*Amendments to the Drawings*

The attached sheet of drawings includes changes to Fig. 1. This sheet, which includes Fig. 1, replaces the original sheet including that same Figure. Figure 3 has been added.

FIG. 1

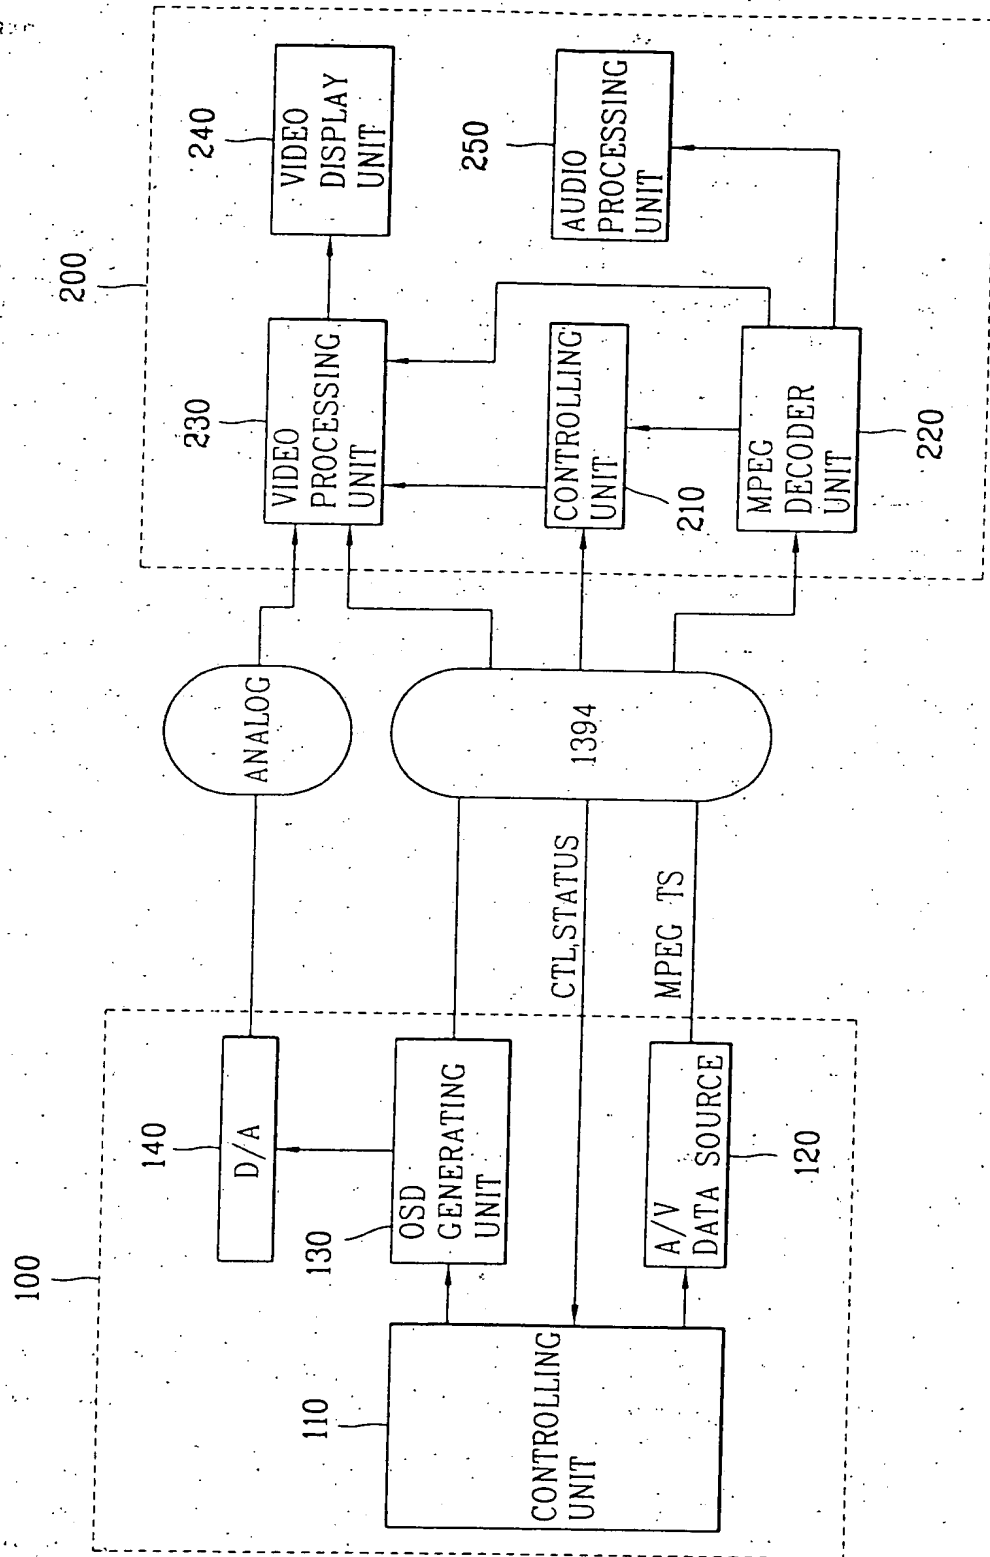
The label "Conventional Art" has been deleted from Figure 1.

FIG.3

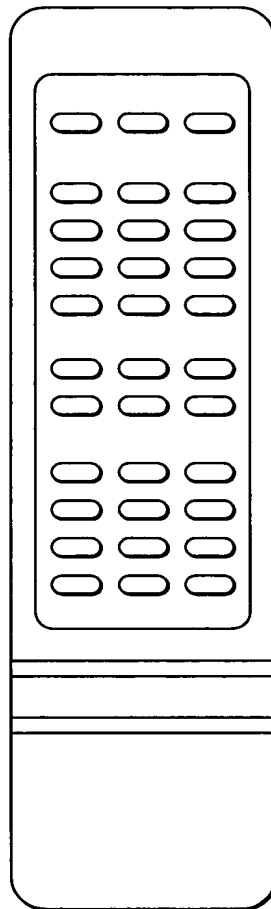
Figure 3 has been added to show a remote control.
